ADDENDUM 1

RE: 000I-289, McCook County – PCN I6VD
Sign Repair along I90 from MRM 356.00 to 367.00

Plotting Date: 07/12/2022
Revised 7/11/22 JP

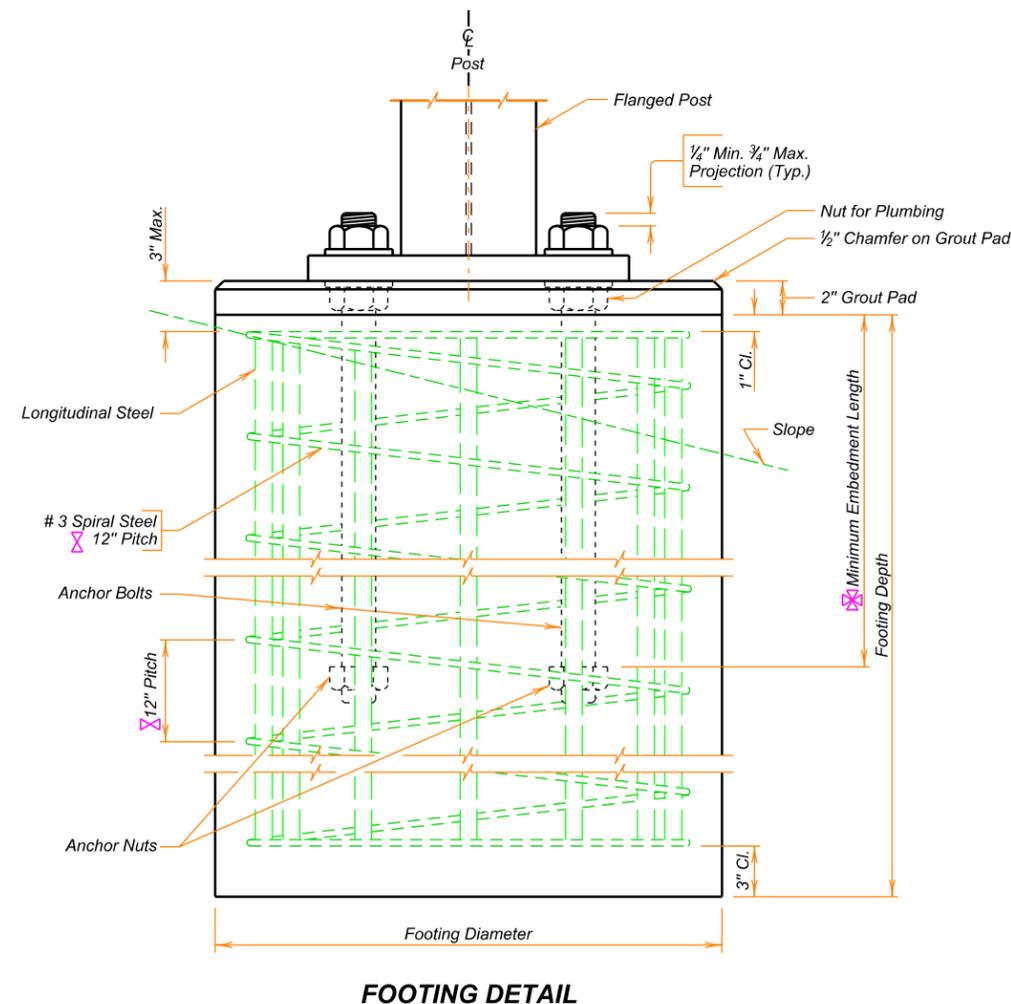
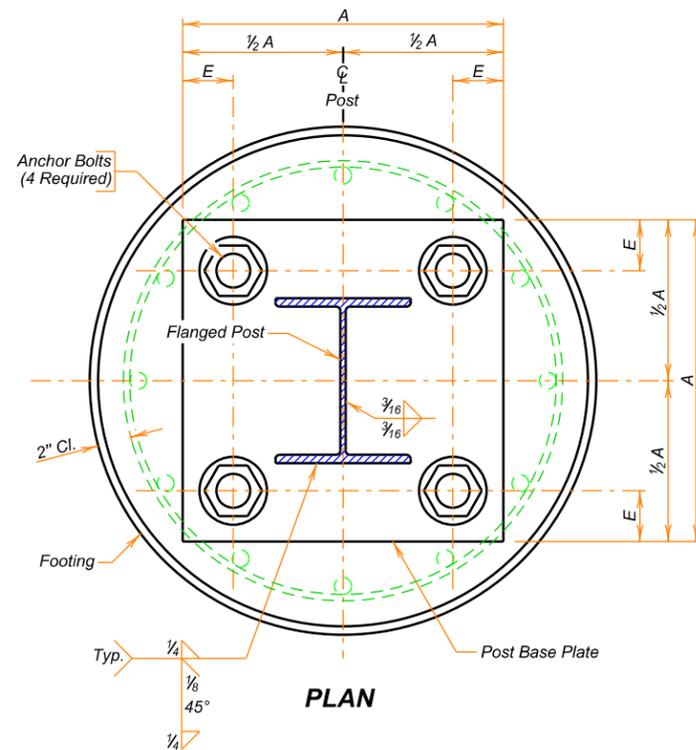
Remove and discard existing Sheet 9 of 11 and replace it with the enclosed revised Sheet 9 of 11. Some footing diameters/lengths were revised. The quantity for 2.25' Diameter Fixed Support Concrete Footing was increased to 90', and 2.5' Diameter Fixed Support Concrete Footing was deleted. Information clarifying new and existing posts was added. Some errant information was corrected.
